Product Change Notice (PCN)

PCN Number: PCN-0539022R-01

Product(s) Affected: CBL-UA-P5-1

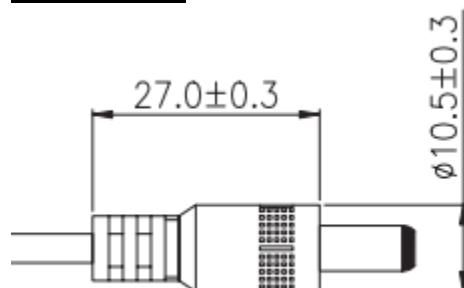
Reason(s) for Change: broken tooling for overmold.

Description of Change: dimension modifications to DC plug overmold as shown below:
